भारत सरकार सड़क परिवहन एवं राजमार्ग मन्त्रालय		Ph.: (0522) – 2967112, 2738226 (Tele-Fax) GOVERNMENT OF INDIA Ministry of Road Transport & Highways
एन. एच. भवन क्षेत्रीय कार्यालय बायोटेक चौराहा, लखनऊ रिंग रोड विकास नगर, लखनऊ – 226 022.		N.H. Bhawan Regional Office Biotech Chowk, Lucknow Ring Road, Vikas Nagar, Lucknow – 226 022.
No. RO/LKO/HA/731(56)/106/2014 / 1243		Dated: 04.12.2014

Sub: Provisional NOC for access permission to the proposed fuel station of M/s Bharat Petroleum Corporation Limited in Km.58 (Ch.57.794, LHS) on NH-731 (Old NH-56), Village Sherpur Parasrampur & Anapur Narainganj, Tehsil Lambhua & District Sultanpur in the State of Uttar Pradesh.

DRAINAGE PLAN OF THE FUEL STATION

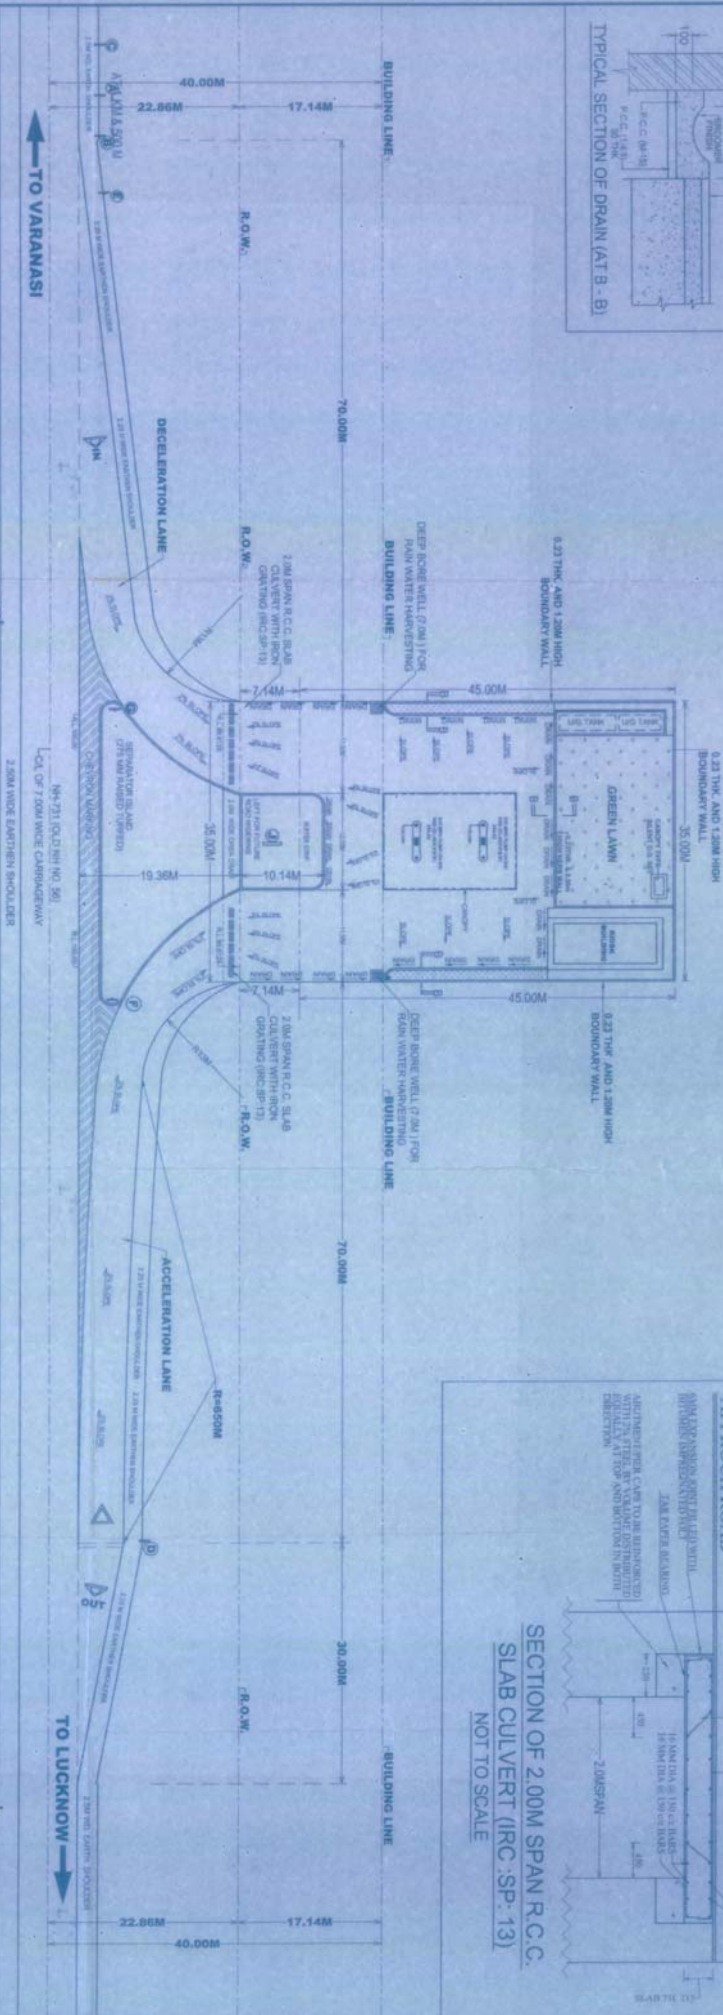
- (iii) For drainage, RCC slab culvert with minimum span of 2m shall be provided as per IRC: SP:13-2004 – "Guidelines for the design of small bridges and culverts". The slab culvert shall be constructed with iron grating of adequate strength in the approaches for drainage of surface water. It must be ensured that outfall of above said culverts shall be connected to nearest drainage facilities available along/across the road.
